Addendum D1

re: **SB885F – Watershed & SB885 Bridge Apartment Interior Upgrade**
Indiana University South Bend
 IU Project #20250140

issue date: **April 1, 2026**

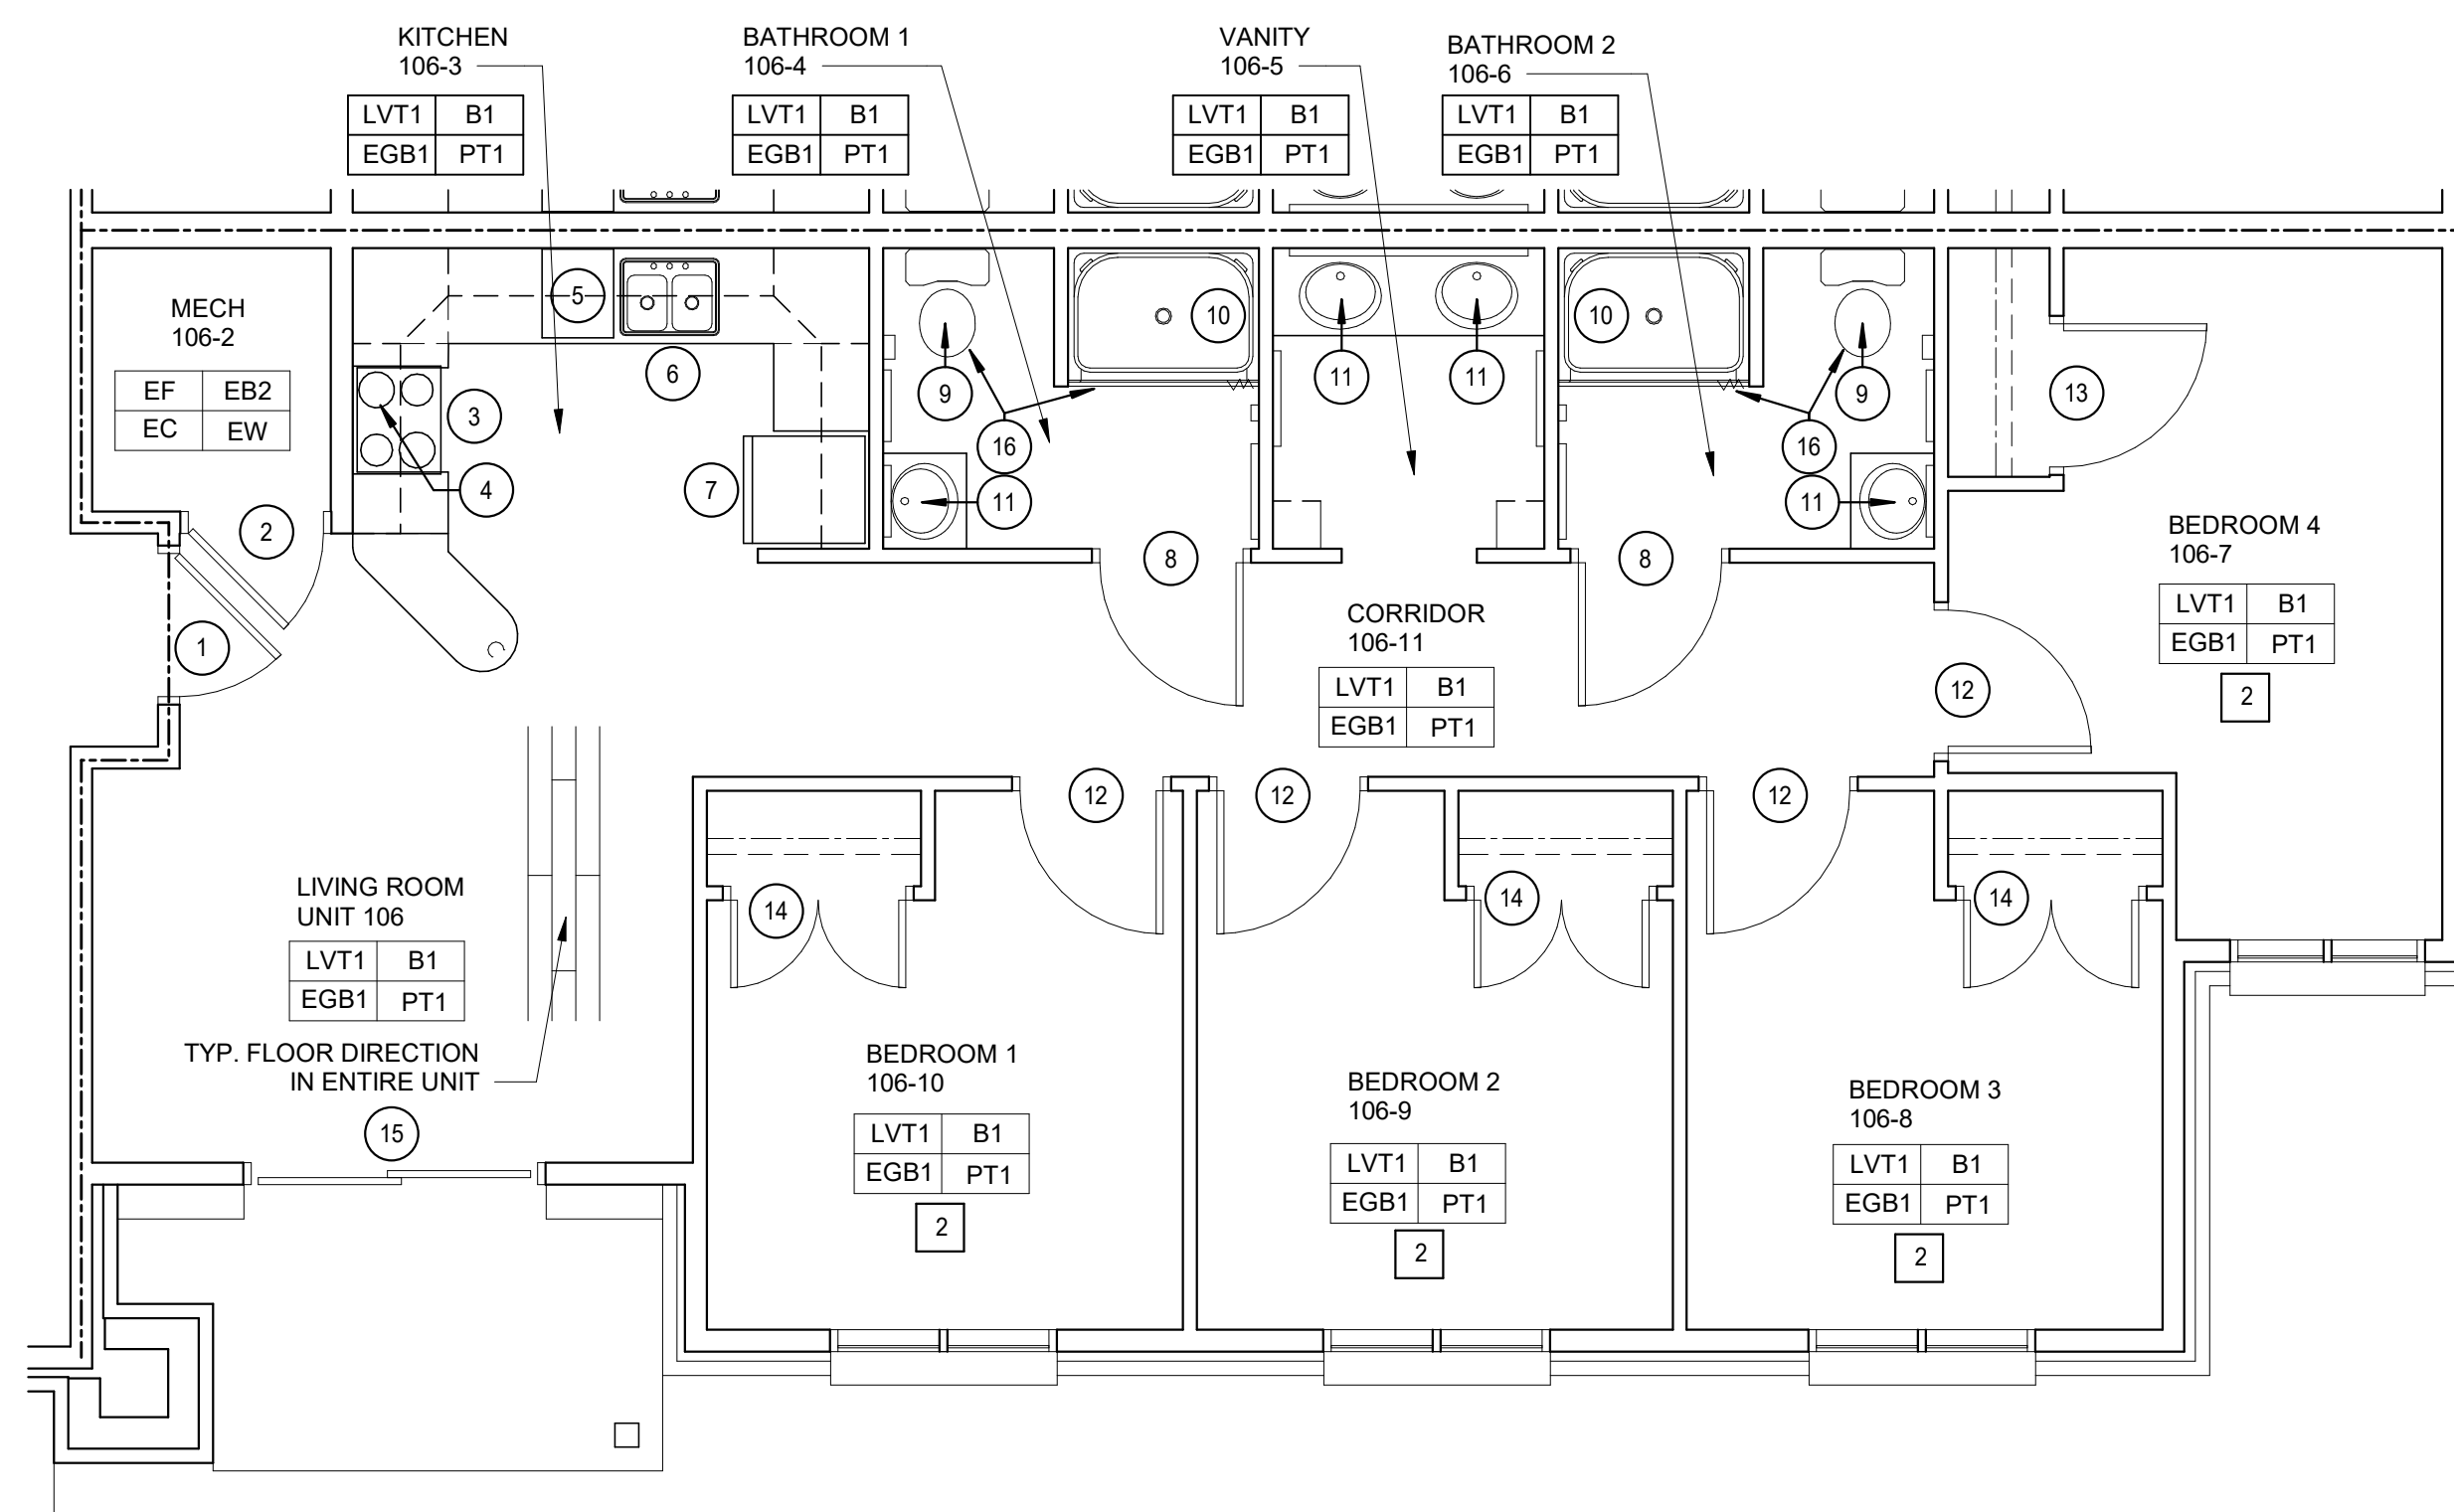
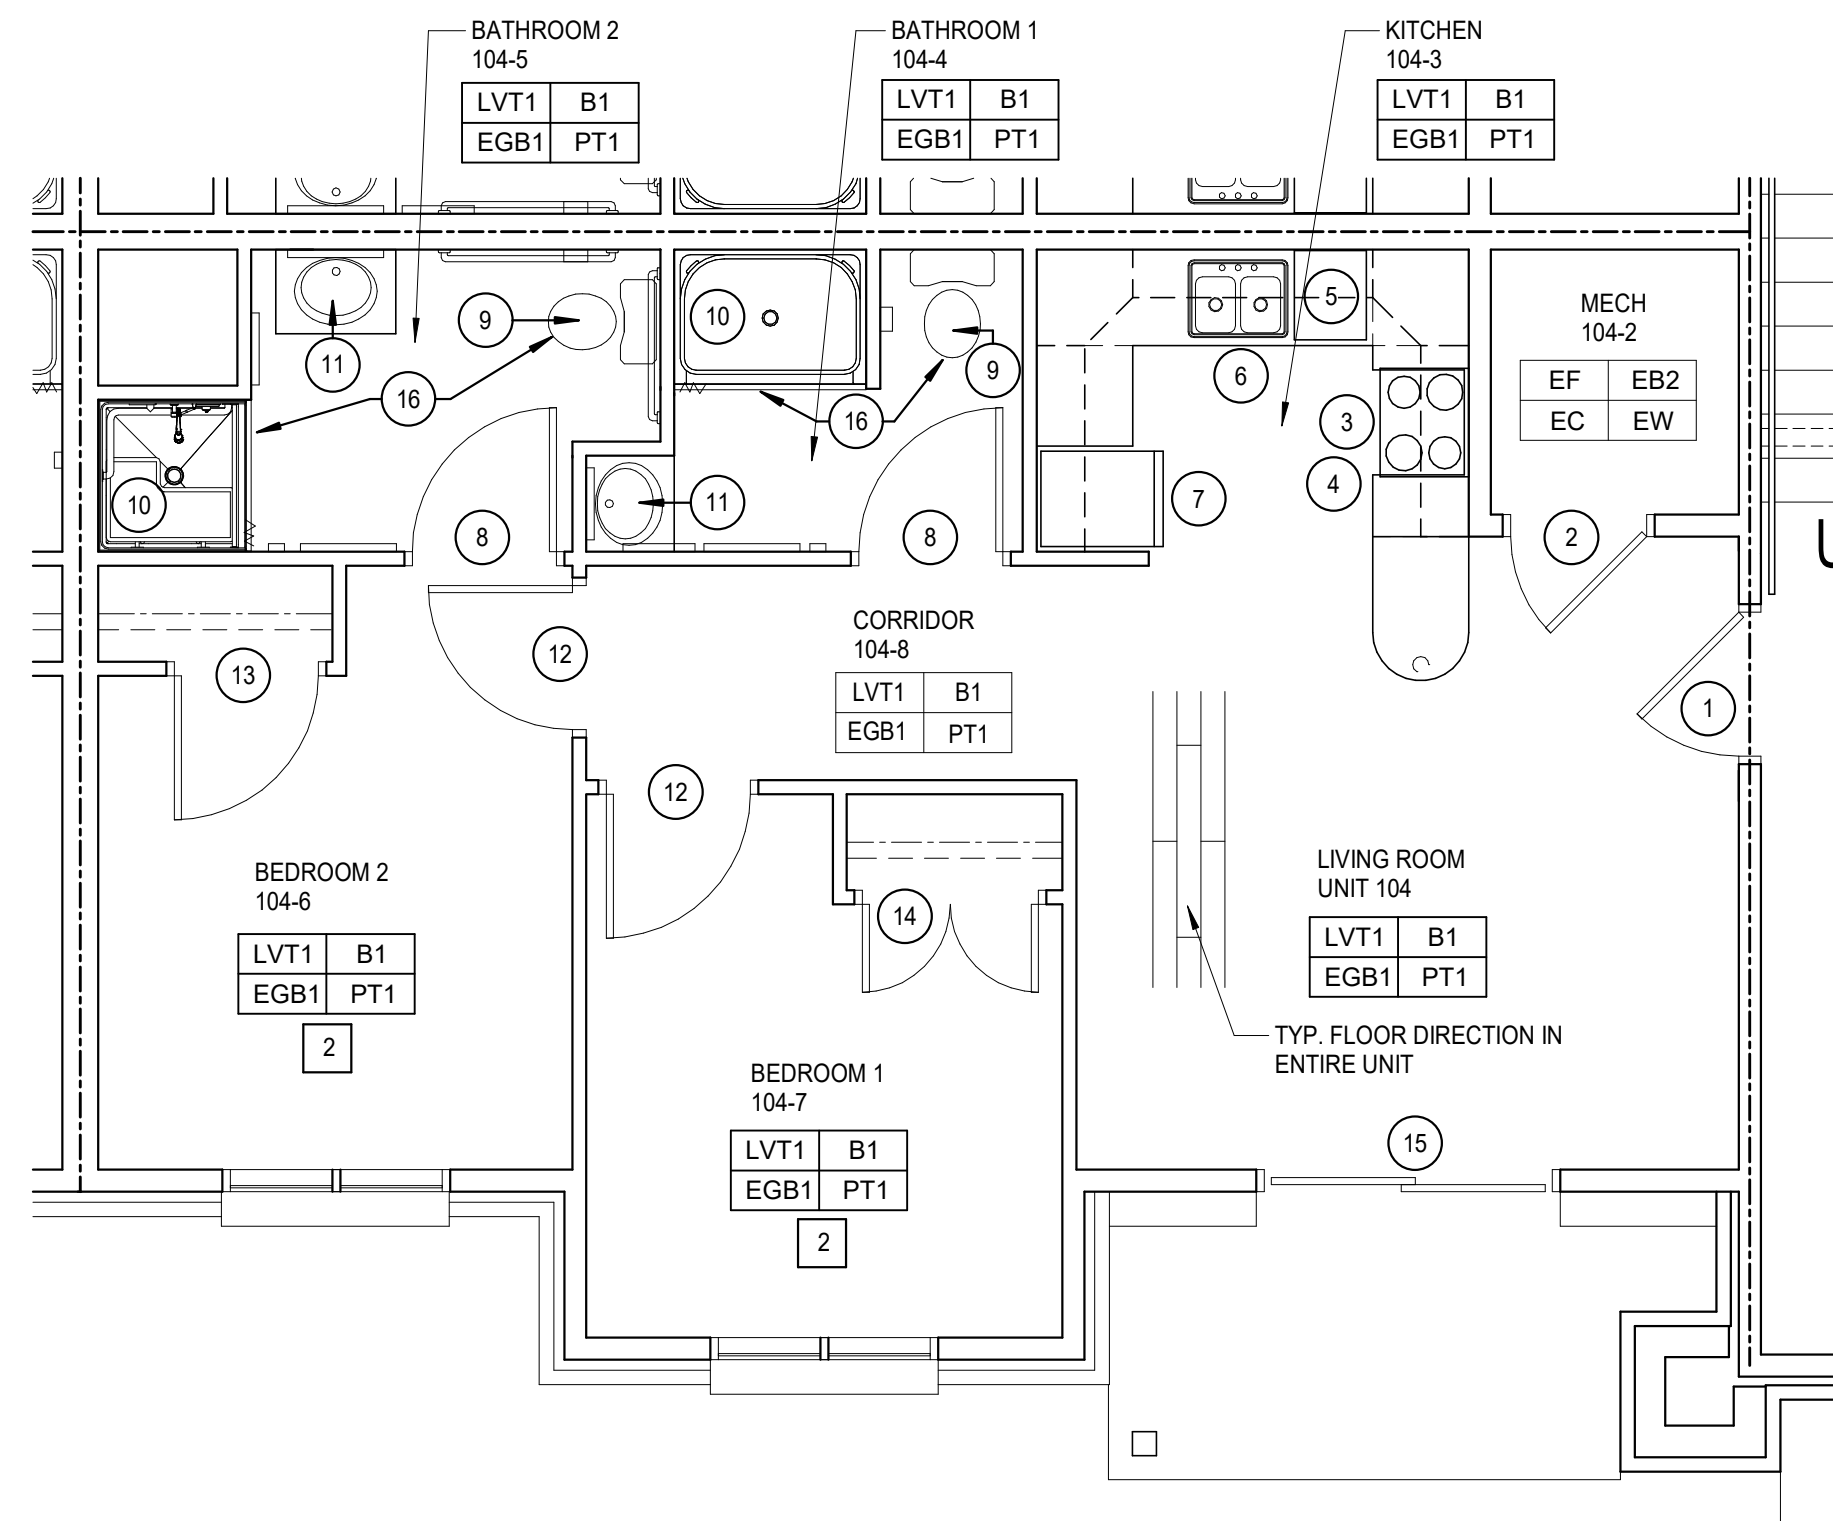
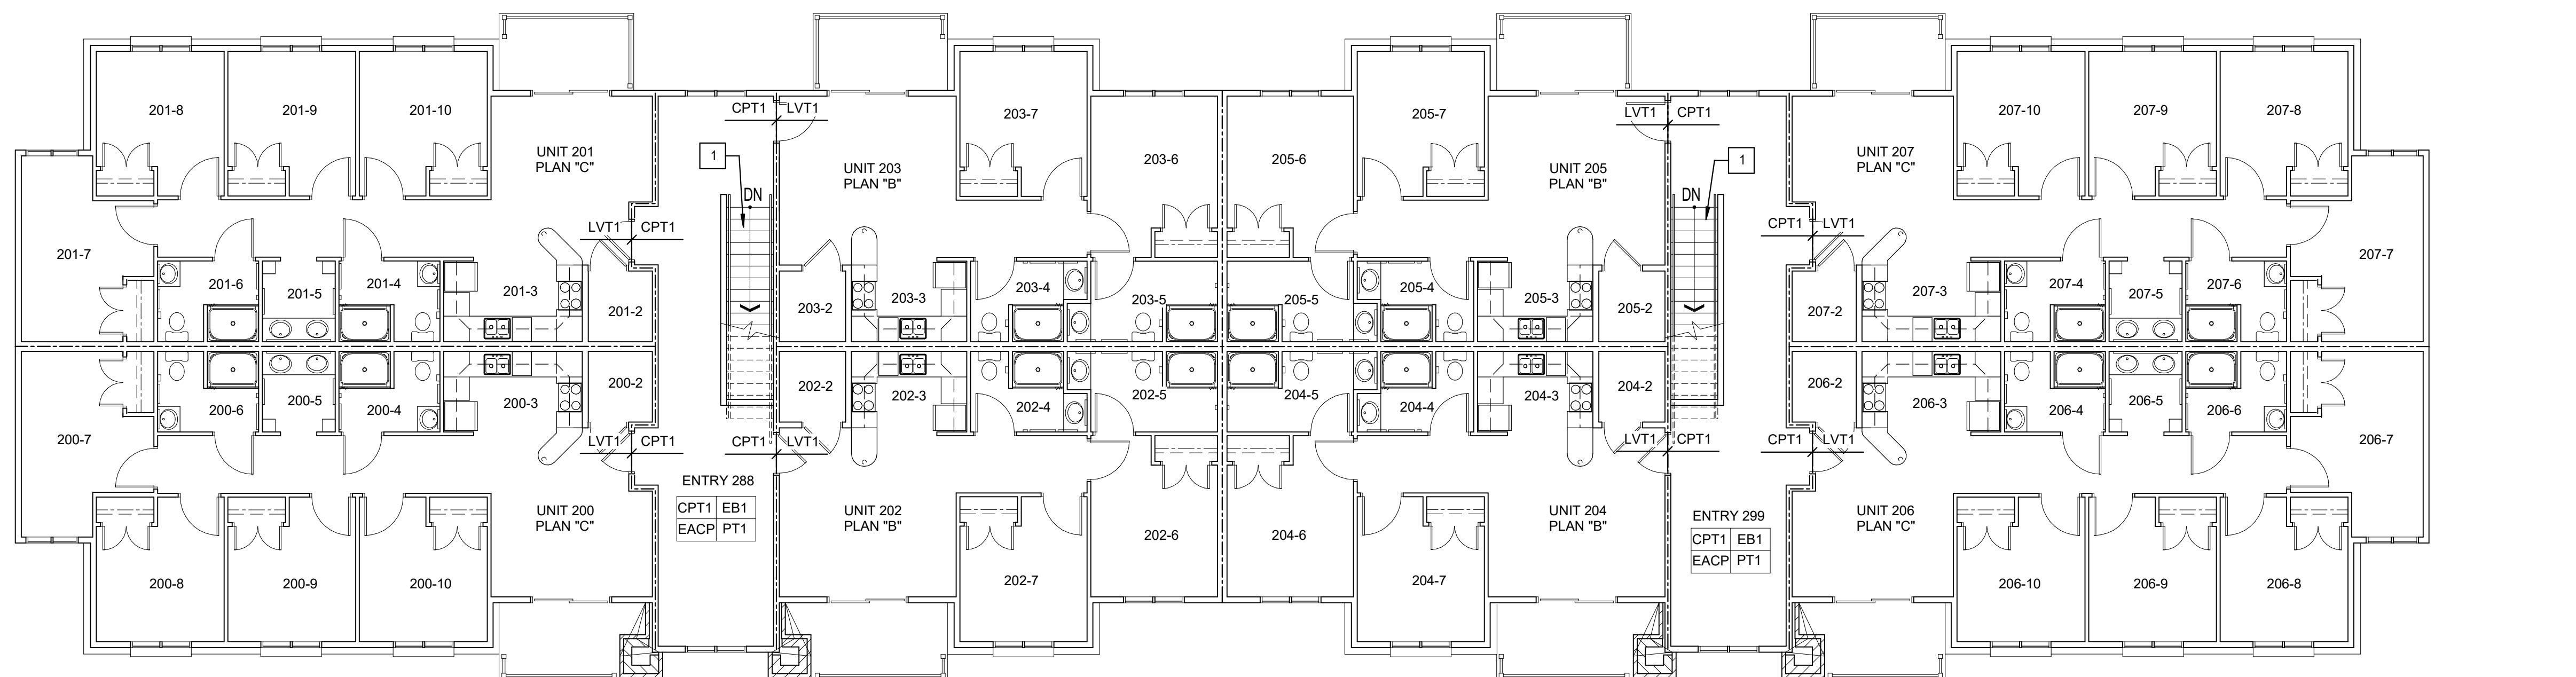
A1.07	DRAWING A2.2 (Drawing Reissued)	<u>CHANGE:</u> Sheet A2.2 reissued to change Specific Floor Plan Note #17.
